**Reserve at Black Mountain
Scottsdale, Arizona**

Case No. 536-PA-2016

Stormwater Review By:
Nerijus Baronas, P.E., CFM
Phone: 480-312-7072
Fax: 480-312-9187
e-mail: nbaronas@ScottsdaleAZ.gov
Review Cycle 1 Date 2-3-17

Re: Drainage review comments for Reserve at Black Mountain.
Case number: 26-ZN-2016
Review date: 11-30-2016

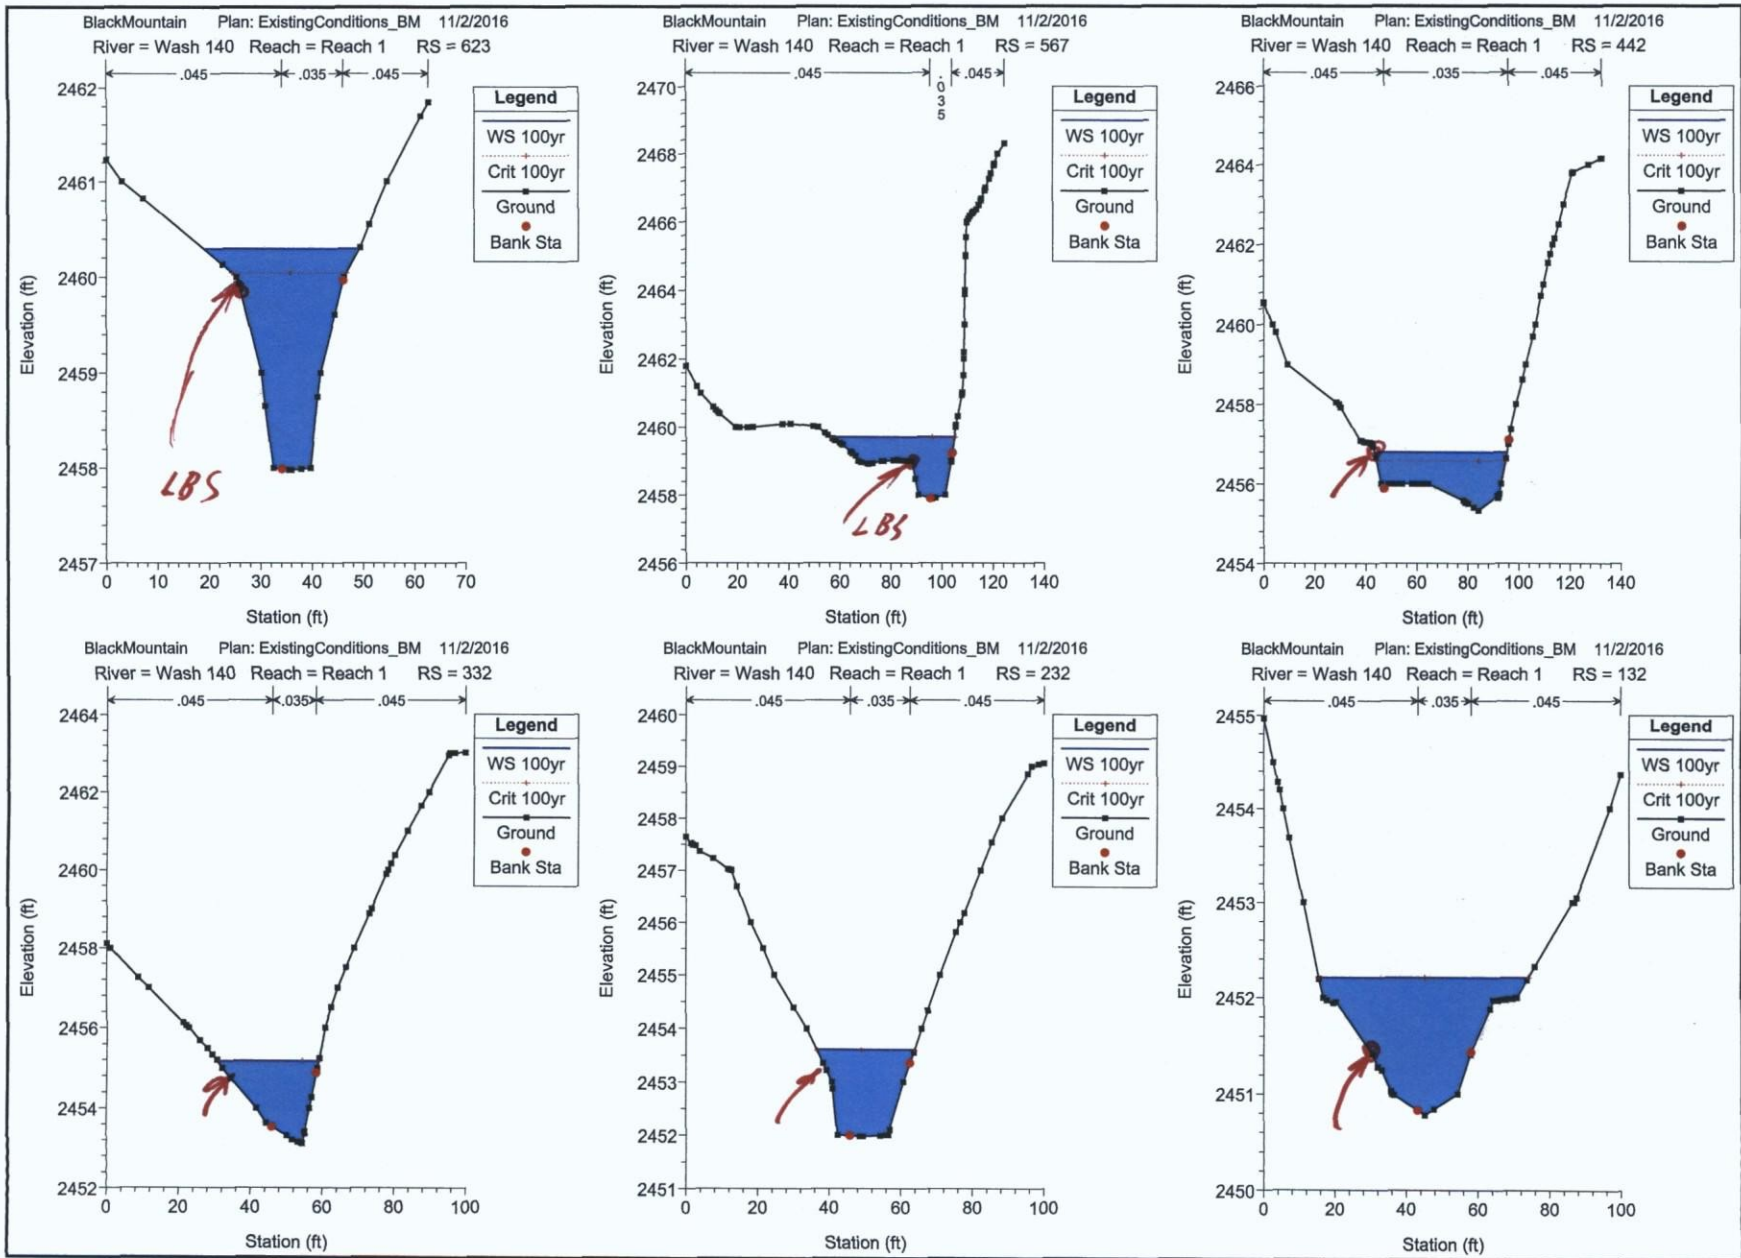
SUBMIT DIGITAL HEC-RAS
 MODEL. REVISE BANK STATIONS. (TYP)

RESERVE AT BLACK MOUNTAIN
FIGURE 6
EXISTING CONDITIONS
HEC-1 SCHEMATIC
DATE: 12/21/2016
SCOTTSDALE, ARIZONA

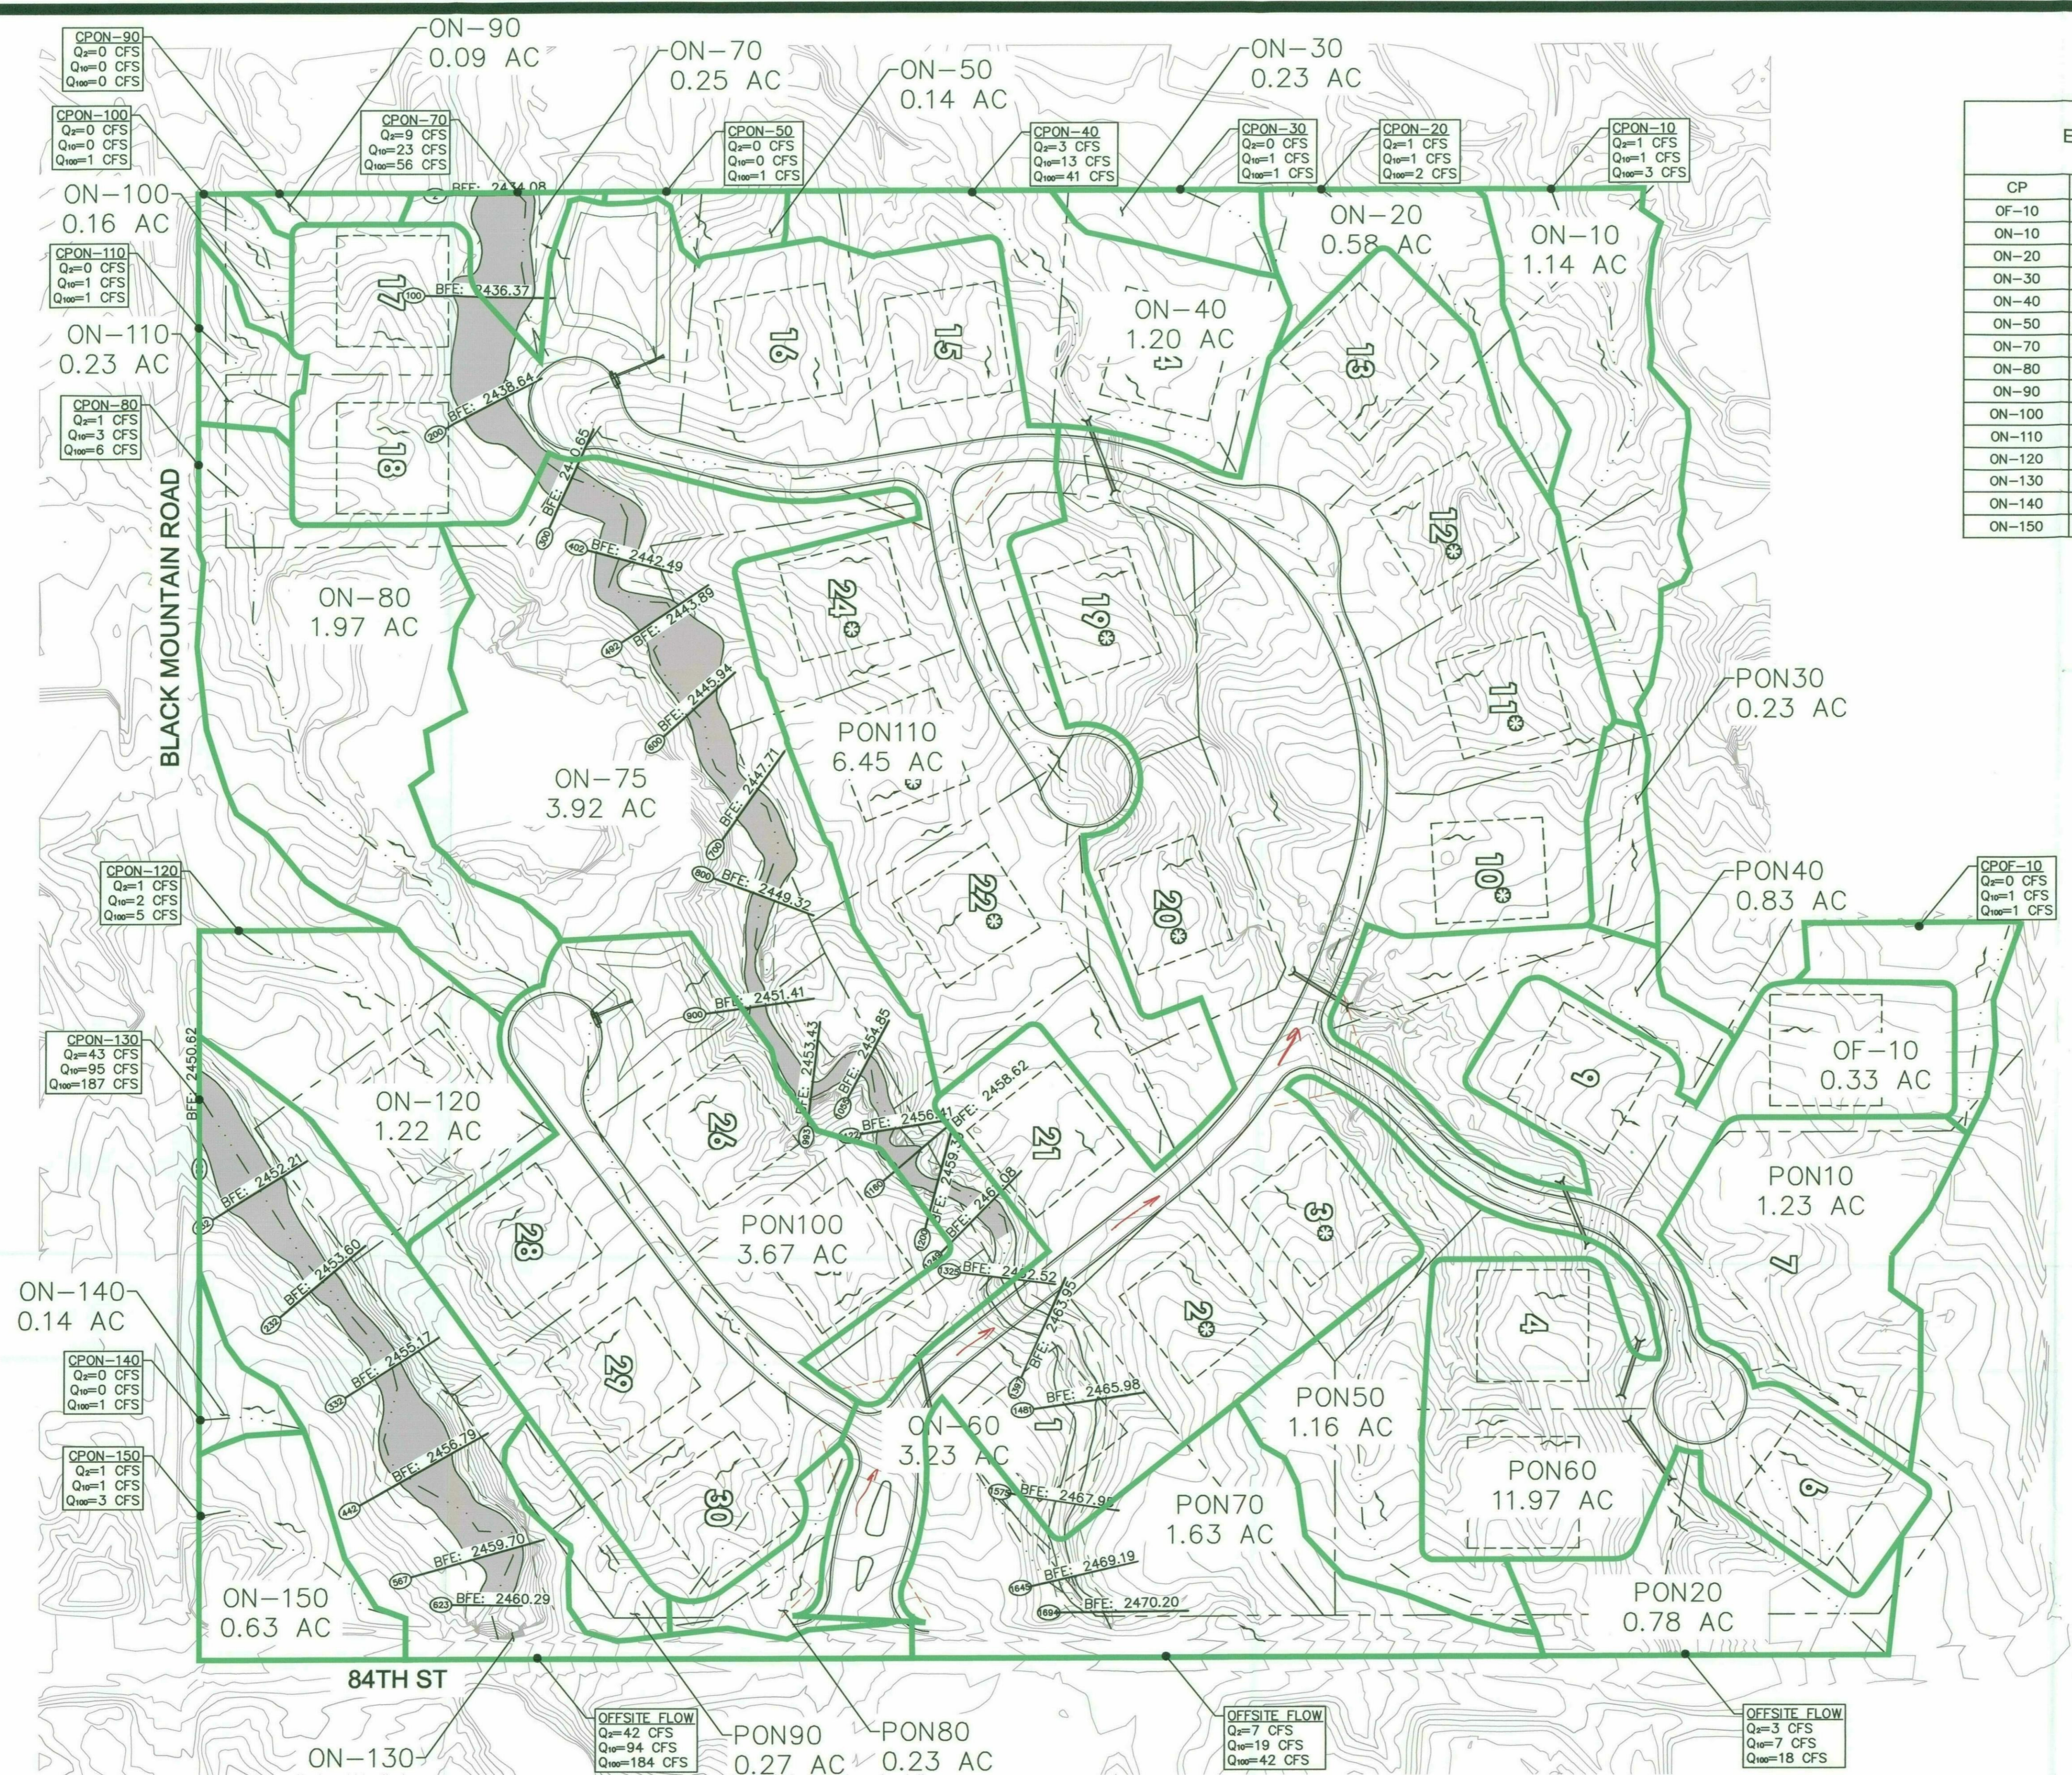
ADD COLUMN FOR PROPOSED CONDITION NODE NAME WHEN DIFFERENT THAN EX CONDITION.

RESERVE AT BLACK MOUNTAIN
 FIGURE 8
 PROPOSED CONDITIONS
 DRAINAGE MAP
 DATE: 12/21/2016
 SCOTTSDALE, ARIZONA

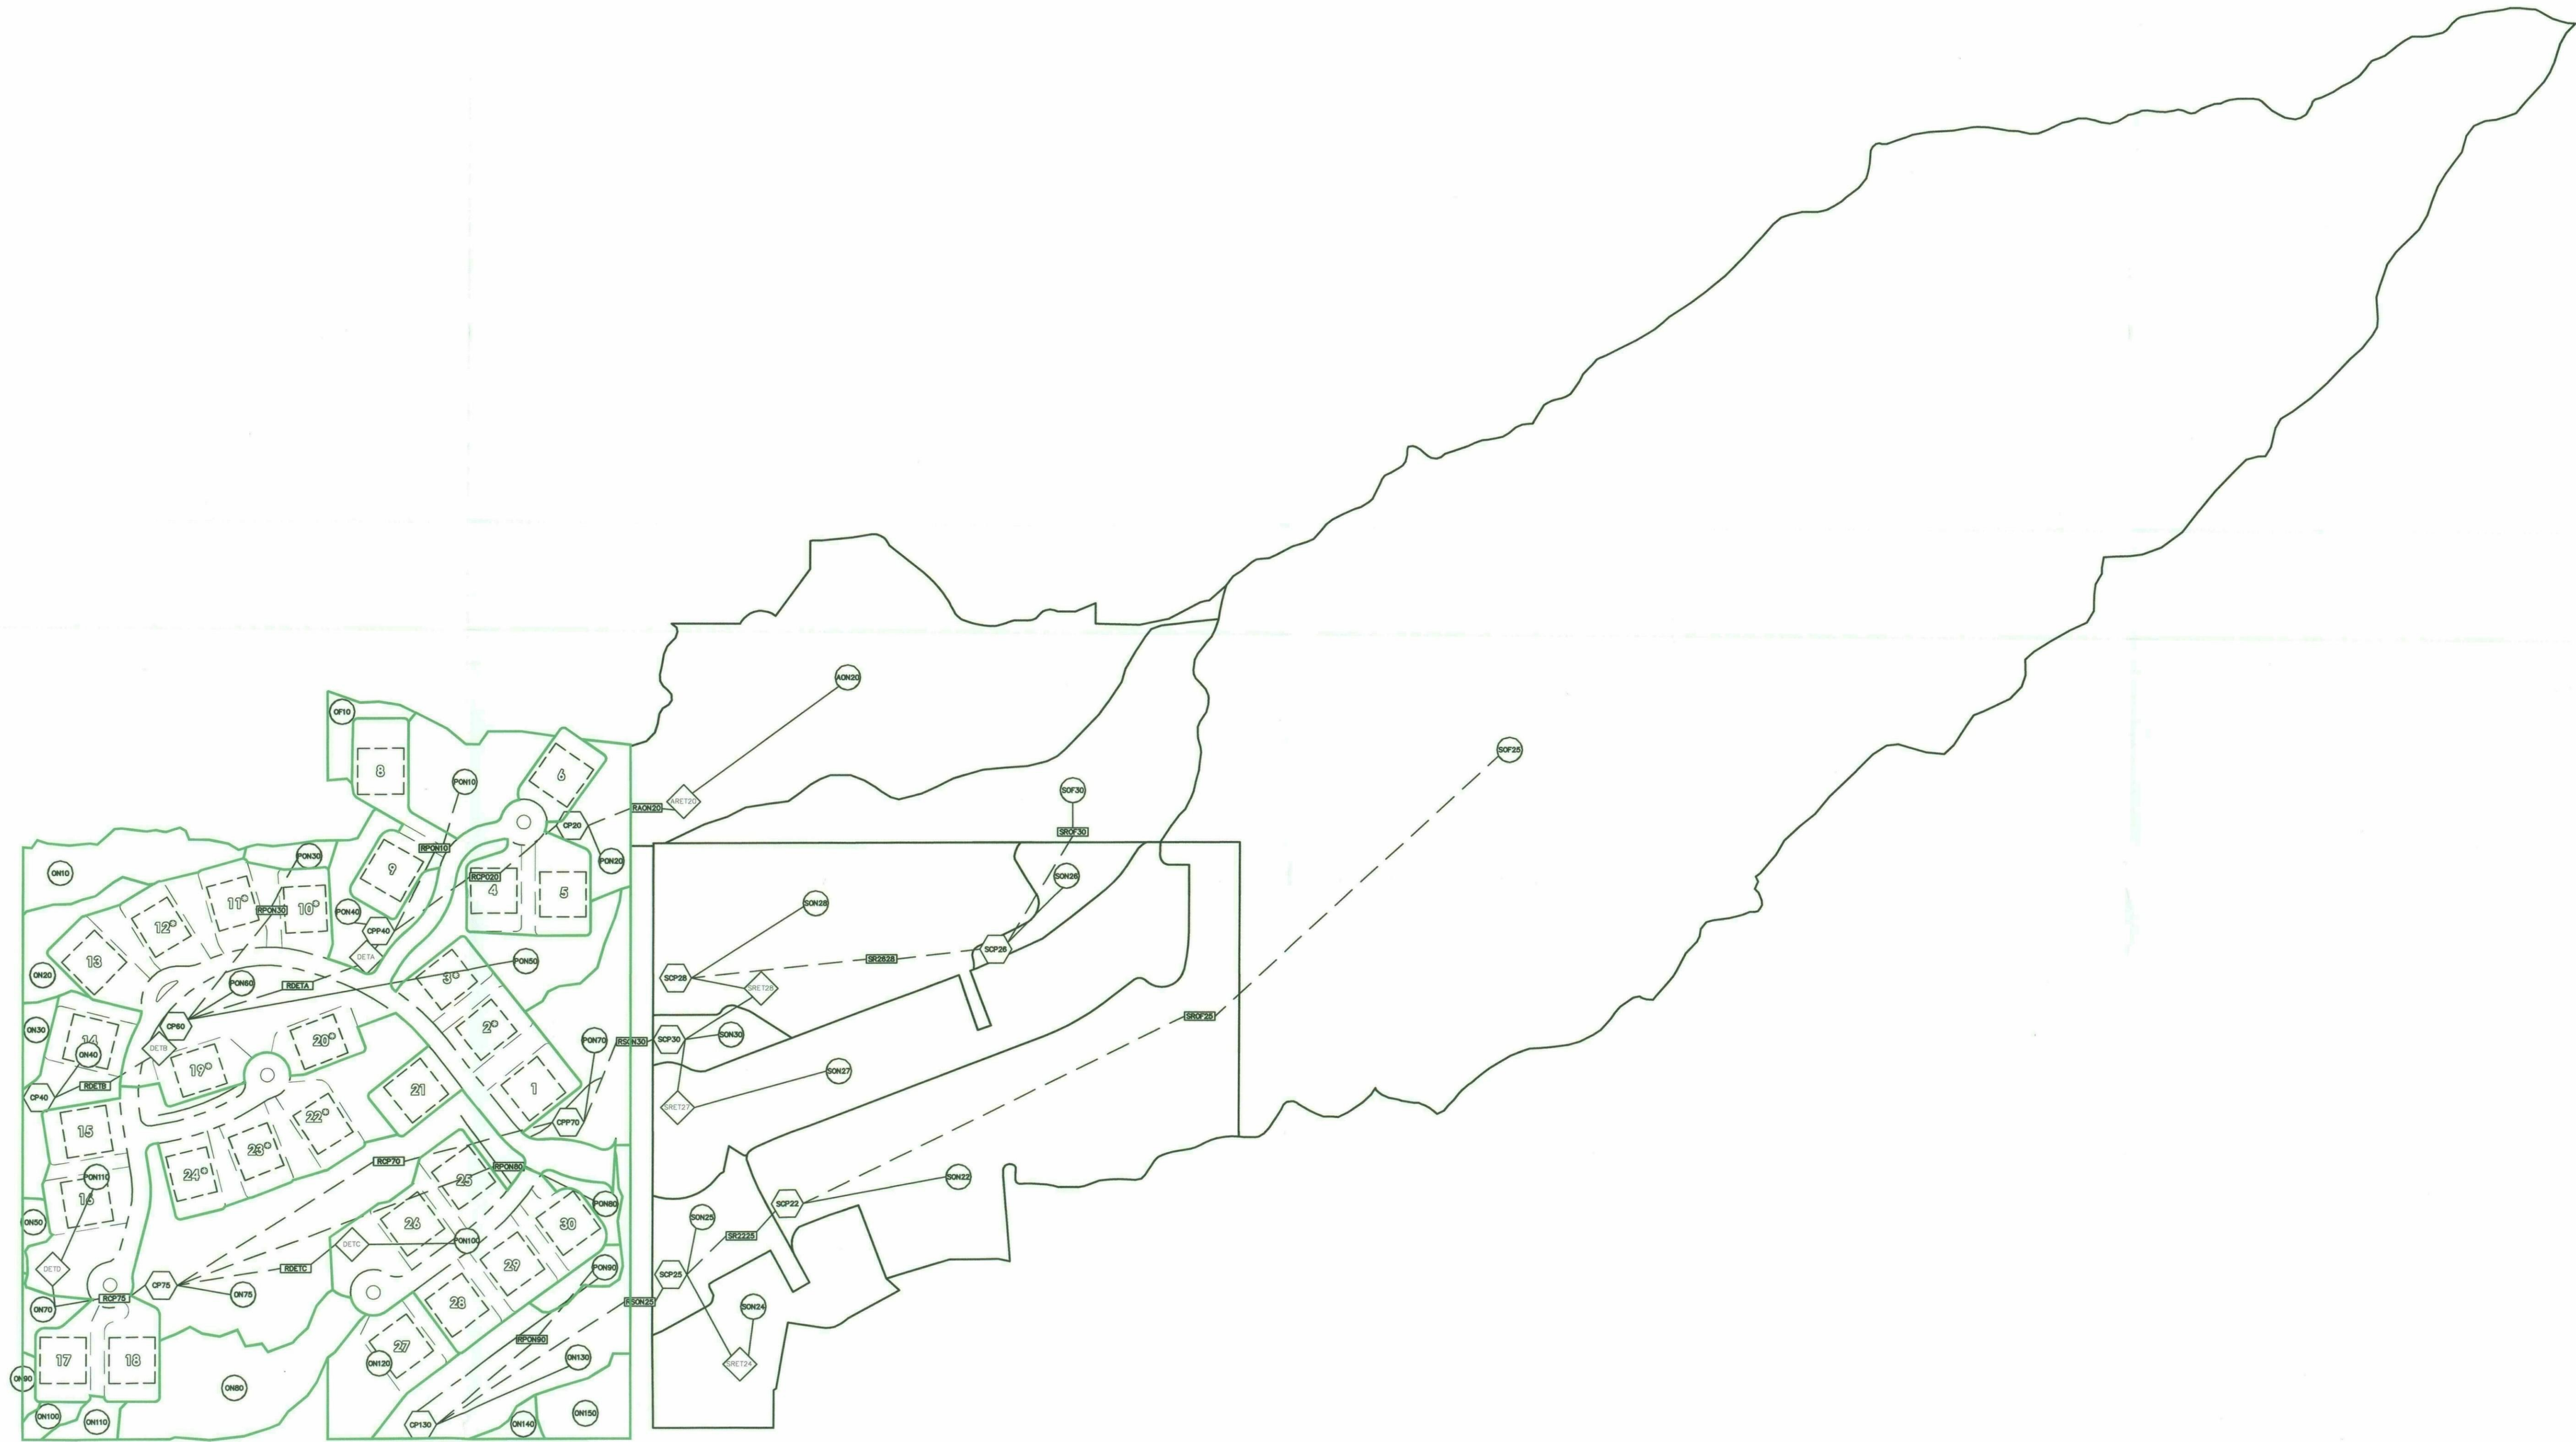
ADD PROPOSED CONTOUR LAYER.
